# HISTORIC AND DESIGN REVIEW COMMISSION

**HDRC CASE NO:** 2017-502  
**ADDRESS:** 1021 N PALMETTO  
**LEGAL DESCRIPTION:** NCB 1369 BLK 6 LOT N 46 FT OF 8 & 9 ARB A-1  
**ZONING:** R-4 H  
**CITY COUNCIL DIST.:** 2  
**DISTRICT:** Dignowity Hill Historic District  
**APPLICANT:** Ricardo McCullough  
**OWNER:** James Benfield  
**TYPE OF WORK:** Construction of 2-story single family residence with rooftop terrace  
**REQUEST:**

The applicant is requesting conceptual approval to construct a new 2-story single family home with rooftop terrace on the vacant lot located at 1021 N Palmetto.

SITE PLAN

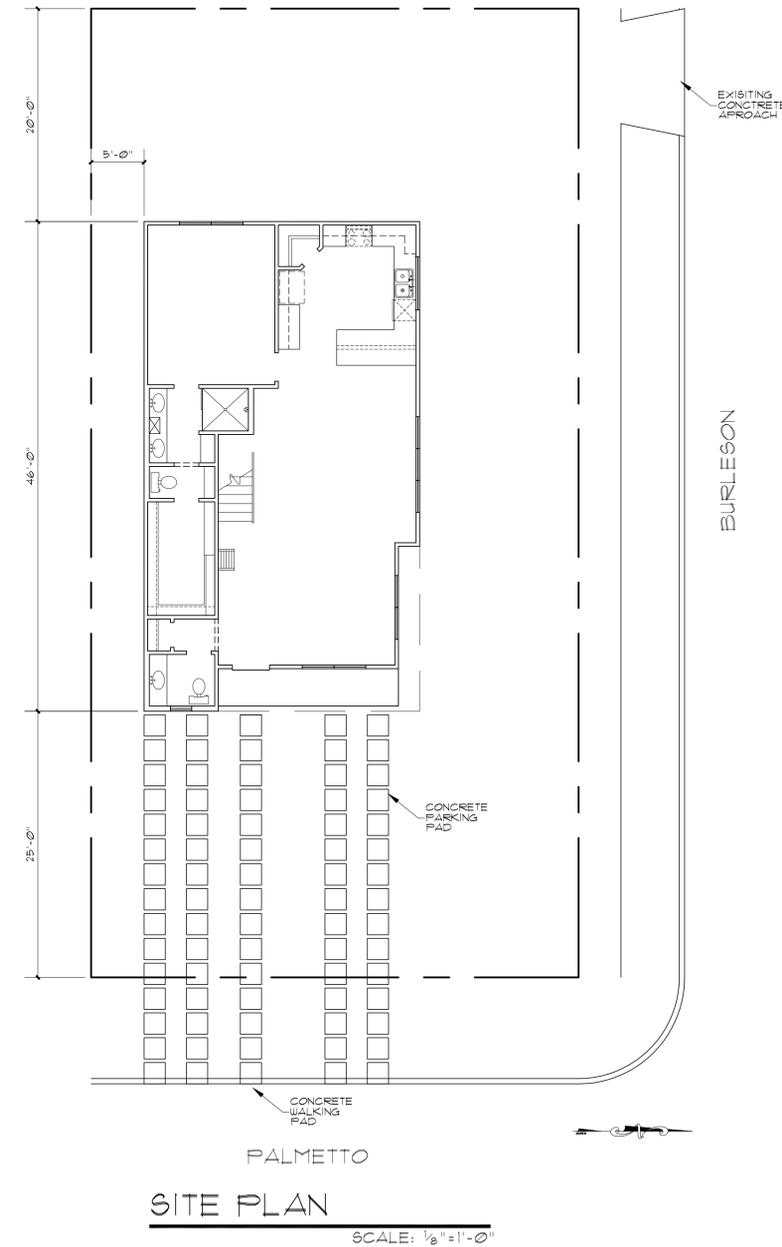
- d. **SETBACKS & ORIENTATION** – According to the Guidelines for New Construction, the front facades of new buildings are to align with front facades of adjacent buildings where a consistent setback has been established along the street frontage. Additionally, the orientation of new construction should be consistent with the historic example found on the block. The applicant has proposed to orient the structure to face N Palmetto Street, which is consistent with the development pattern found on the block. The applicant has proposed a setback that per the application documents is to be within five feet of the adjacent setbacks. The applicant is to provide field measurements to confirm setbacks of adjacent structures and proposed a setback that is consistent. Staff finds the proposal conceptually consistent with the Guidelines.

- p. DRIVEWAY: LOCATION – According to the Historic Design Guidelines for Site Elements, driveways that are similar to the historic configuration found on site or in the district should be incorporated. Currently, a curb cut exists off Burleson. The proposed new driveway placement, in conjunction with its materiality and parking strategy, is not consistent with the historic development pattern of the district. Staff finds the proposed location and configuration inconsistent with the Guidelines.

- r. WALKWAY – The applicant has proposed to install three individual paver walkways leading from N Palmetto St to the front of the house. One leads to the front door and the other two terminate at the front façade with no entrance. Staff finds the proposed walkway leading to the front door consistent with the guidelines, but finds no precedent in the district for walkways leading to facades with no openings. Additionally, pavers are not consistent with the materials used in front approaches in the Dignowity Hill Historic District, where poured concrete is common.

- i. That the applicant submits a street elevation noting the proposed new construction in comparison with neighboring historic structures to determine the new construction's impact and proposed a consistent setback.

- vii. That the applicant implements a concrete driveway at the rear of the property in lieu of pavers to be more consistent with the development pattern of the district as noted in findings o and p.
- viii. That the applicant reconfigures the front walkway to be more consistent with those found within the Dignowity Hill Historic District as noted in finding q. The applicant should incorporate concrete in lieu of pavers.

**FRONT ELEVATION CONCEPT #3**

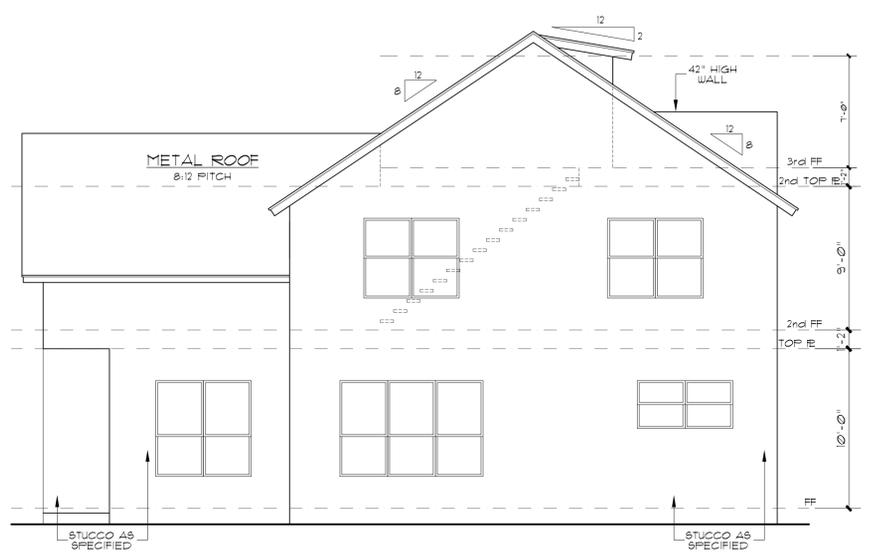
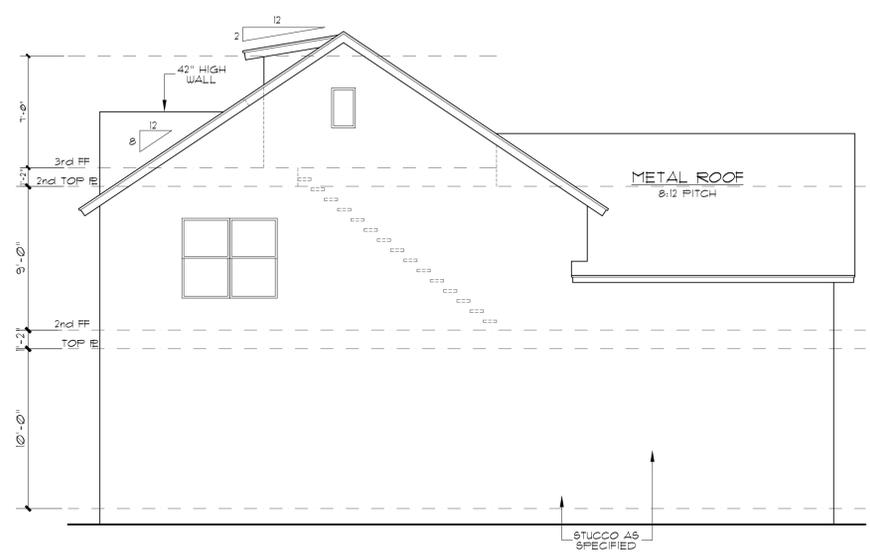
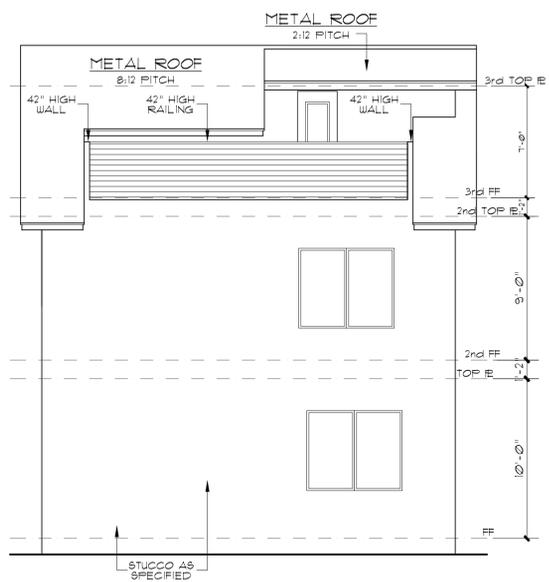
- f. **ENTRANCES: PORCH** – The applicant has proposed a front entrance that projects slightly from the primary setback of the front façade. Historic structures throughout the Dignowity Hill Historic District feature distinct porches that engage the pedestrian streetscape and feature numerous widths, depths and roof styles. The applicant's absence of a definitive porch is not appropriate and inconsistent with the Guidelines.

- g. **SCALE & MASS** – Per the Guidelines for New Construction 2.A.i., a height and massing similar to historic structures in the vicinity of the proposed new construction should be used. The applicant has proposed a two story structure with a rooftop terrace. The highest point of the structure is indicated to be 29'-4" without considering the foundation height. The height is generally consistent with the two-story structures nearby; however, the block is predominantly single-family homes with a maximum height of 20 feet at the roof ridgeline. Additionally, the massing of the structure, primarily the right façade that will face Burleson, is not similar to historic structures and is not appropriate for the site, nor consistent with the Guidelines.

- i. **ROOF FORM** – The applicant has proposed a gable roof form and a habitable flat rooftop terrace. While the gable pitch is commonly found in the Dignowity Hill Historic District, the treatment of the rear façade with the rooftop terrace, as well as the proportions and height, are deviations from common patterns. Guideline 3.A.iv states that new metal roofs should be constructed in a similar fashion as historic metal roofs. Staff finds the proposed roof forms inconsistent with the Guidelines as proposed.

- j. **WINDOW & DOOR OPENINGS: PROPORTIONS AND PLACEMENT** – Per the Guidelines for New Construction 2.C.i., window and door openings with similar proportions of wall to window space as typical with nearby historic facades should be incorporated into new construction. The applicant has proposed window openings that are not consistent with those found on historic structures in the neighborhood, either in width, height, or configuration. Additionally, the left elevation is completely void of fenestration. Guideline 2.C.ii states that blank walls should be avoided. The openings are inconsistent with those found on historic structures in the area, specifically the Craftsman structures found in the immediate vicinity. Staff finds the proposal inconsistent with the Guidelines and incompatible for the district.

- n. ARCHITECTURAL DETAILS – New buildings should be designed to reflect their time while representing the historic context of the district. Additionally, architectural details should be complementary in nature and should not detract from nearby historic structures. The architectural details of the proposal are not consistent with context of the neighborhood, which features Craftsman bungalows, Queen Anne cottages, and Folk Victorian homes in the direct vicinity. Staff finds the proposal inconsistent with the Guidelines.

- ii. That the applicant proposes a front porch and front massing that are consistent with the Guidelines and complementary of historic front porches found in the Dignowity Hill Historic District as noted in finding e.

- iii. That the applicant explores overall massing similar to historic structures in the vicinity as noted in finding f.
- iv. That the applicant proposes a fenestration pattern and window opening proportions that are more consistent with the Guidelines, the OHP Window Policy document, and the historic examples found in the Dignowity Hill Historic District as noted in finding i.

- vi. That the applicant explores ways to incorporate architectural details and materials that are representative of the historic context of the district as noted in findings k and m.
